Moonlux Knit Garments Ltd Safa Knitwear Ltd.

B/11, MS Tower-3, Siddhirgonj Pool, Siddhirgonj, Adamji, Narayanganj
(23.689641, 90.51467)
28th August 2016

Insufficient documents and discrepancies between drawings & site observations

Typical floor layout plan

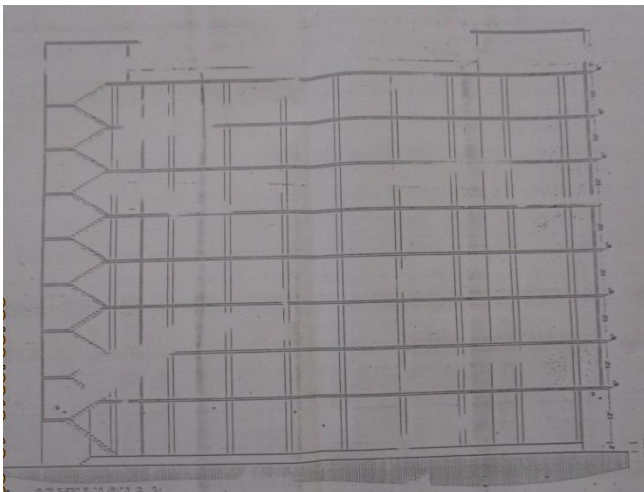
Beam layout
plan on stair
portion does
not match
with
drawings.

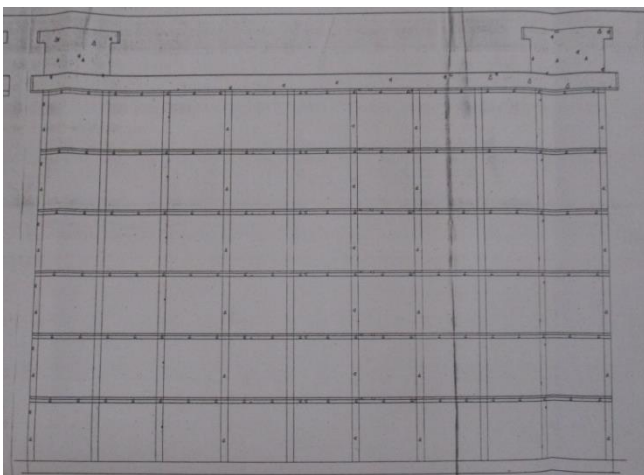
The North side cantilever of the factory building does not shown in both drawings. The toilets and walls position do not match with drawings.

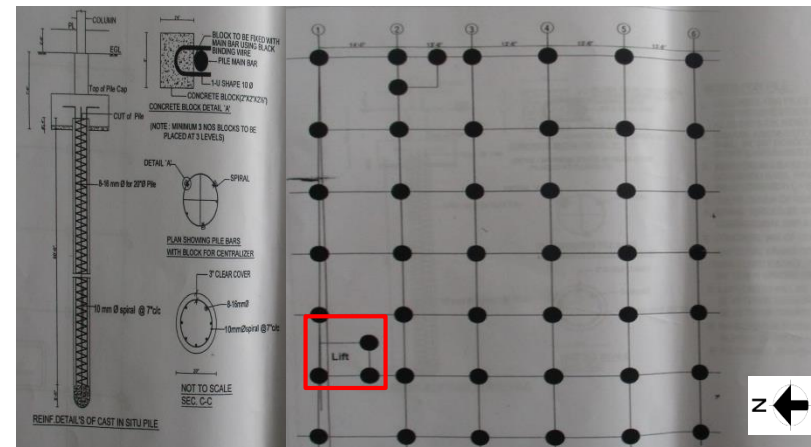
Local authority Permit drawing
shown 8 storied building

industrial permit drawing shown 6
storied

Factory Building 4 storied

The floor layout plan and section does not match with industrial permit and local authority permit drawings. The architectural drawings of the building wasn't available during inspection. The factory building was constructed only 4 storey.

Section and Layout plan of Pile foundation

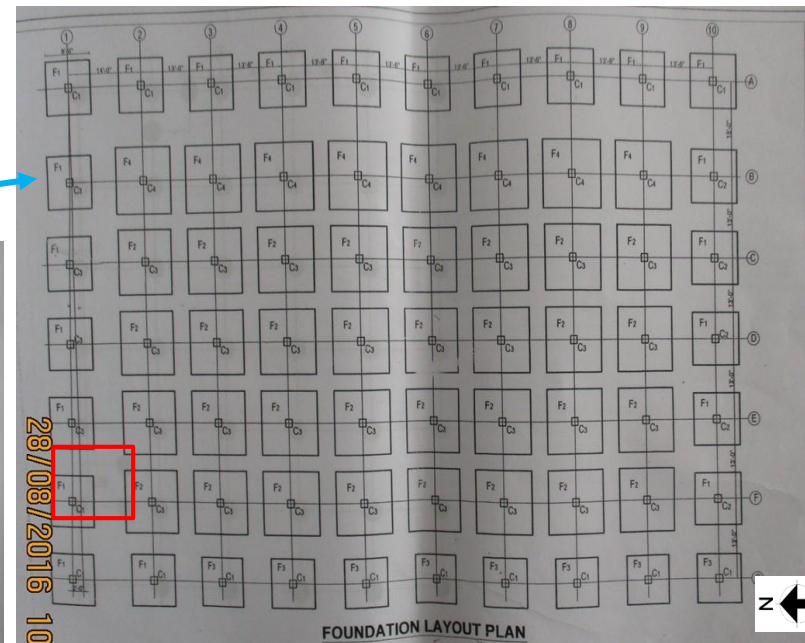
We were provided a set of structural drawings in which two type of foundation drawing was found which is vague. The lift core column and foundation drawing was not found in those drawings.

Item No.	Observation	Recommended Action Plan	Recommended Timeline
1	Inadequate documents and discrepancies between drawings & site observations	Factory engineer to detail investigate the foundation system of the building and update the drawings accordingly.	6-weeks
2	Inadequate documents and discrepancies between drawings & site observations	Building Engineer to survey as constructed building and prepare a set of as-built drawings.	6-weeks
3	Falling hazards on the roof and protected reinforcement from corrosion	Secure constructed area around the perimeter wall to exclude any possible falling hazard.	Immediate - Now
4	Falling hazards on the roof and protected reinforcement from corrosion	All exposed reinforcement is to be protected from corrosion which may cause degradation of the concrete.	6-weeks
5	Dampness and cracks observed on walls	Sections of plaster finish to columns and beams to be removed to investigate if cracks penetrate the building structure at all cracked areas.	6-weeks

Column layout plan

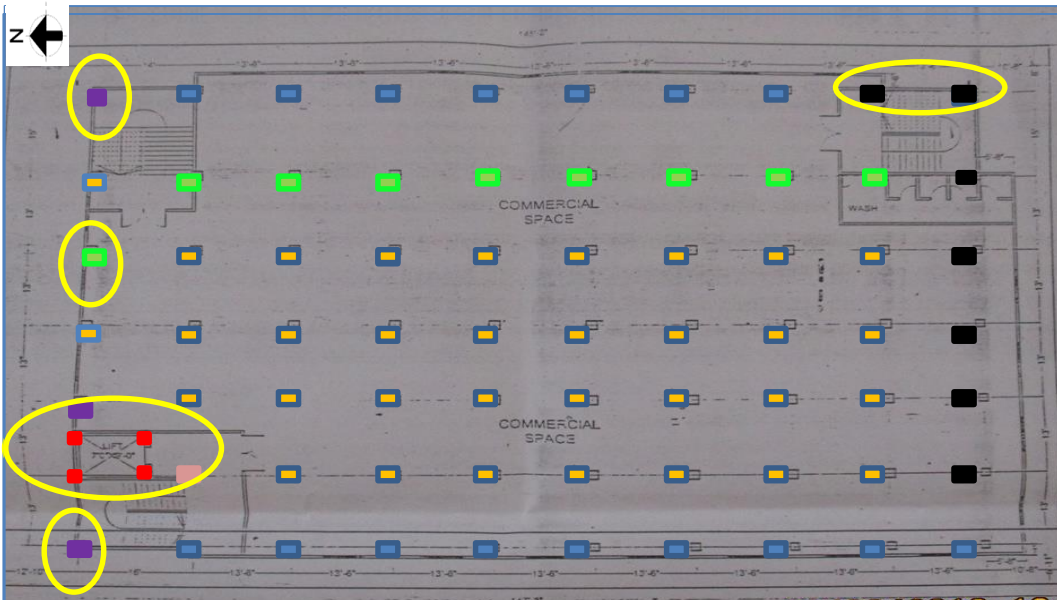
L-shape columns shown as red mark does not exist in column schedule and layout plan. The no. of column reinforcement marked by yellow circle on column layout plan does not match with mentioned column schedule.
